Report to Sydney West Joint Regional Planning Panel

JRPP No.	2015SYW191 DA
DA No:	JRPP-15-01997
Proposed Development:	Torrens title subdivision (stages 15A-23) into 635 residential lots (as amended), 2 superlots, and 4 residue lots, construction of public roads, temporary Basin No 4 and 2 drainage channels, with associated subdivision works, including tree removal, street trees, and an acoustic barrier
Development Type:	Capital Investment Value > \$20 million
Lodgement Date:	4 September 2015
Land/Address:	Lot 168 DP 1191299 Elara Boulevard and Lots 111 and 112 DP 1190510 Richmond Road, Marsden Park
Land Zoning:	Part R2 Low Density Residential Part R3 Medium Density Residential Part SP2 Infrastructure (Drainage) Part SP2 Infrastructure (Classified Road) Part RE1 Public Recreation
Capital Investment Value of Approved Development:	\$28,700,000
Applicant:	GLN Planning Pty Ltd on behalf of Stockland Development Pty Ltd
Report Author:	Ruth Bennett, Senior Project Planner

Figure 8. Amended Stage 15 and 16 Development Proposal with Lot Yield of 635 Lots
(Source: Cardno, Dwg. No CardnoUT-CV-ST05-1101, Revision 2)

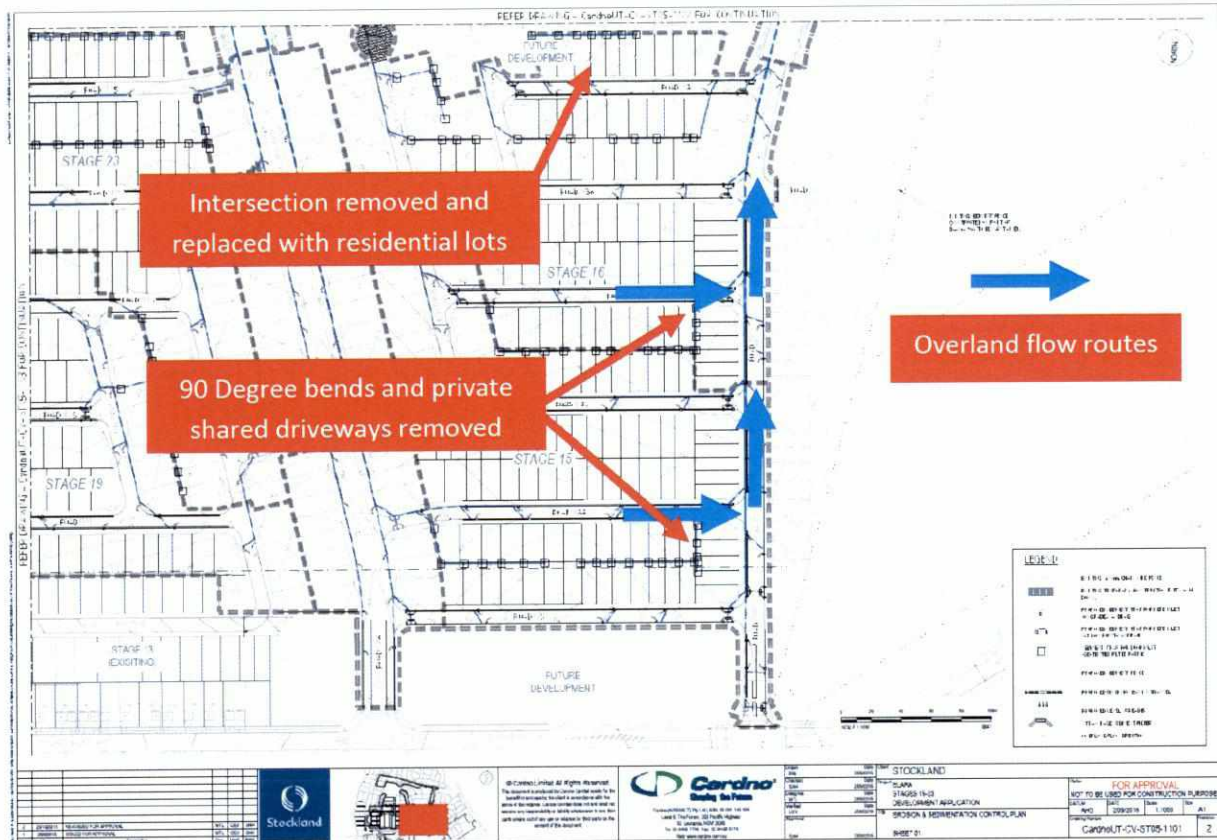
- Road connections along the western property boundary have been modified to integrate with the road network designed for Precinct 2 by providing a western link road to join Lot 112 DP 1190510 with Lot 10 in DP 1178982 situated to the west. This proposed road pattern amendment was at the request of NSW RMS.

- An intersection to be deleted from Stage 16.
- Proposed departure from the adopted DCP road pattern in Stages 15 and 16 with a revision of the road layout to satisfy Council's stormwater drainage criteria, to eliminate the 90 degree bends in the local road network, and remove private shared driveways from the proposed development, in order that all stormwater drainage flows are wholly contained within Council's road reserve.

- A departure from the minimum local street widths and road widths.
- Configuration of collector roads to include the creation of a 'green link road' to link the public recreation areas in the north of Stockland's development with the public recreation areas in the south.

The development complies with the Growth Centres DCP, with the exception of the above minor variations from the ILP. These variations have previously been approved in Stockland's Precinct 1 and will provide a consistent road design in the Elara residential estate.

The proposed variations from the ILP are considered acceptable as it results in a more desirable traffic management outcome for the area as a whole, and creates a better stormwater engineering outcome with all stormwater drainage flows being wholly contained within Council's road reserve to ensure compliance with Council's Engineering Guide for Development 2005. As a result of these changes, the street network and street hierarchy have been improved, with increased linkages to arterial and sub-arterial roads. See Figure below. Refer to assessment in **Attachment 5**.
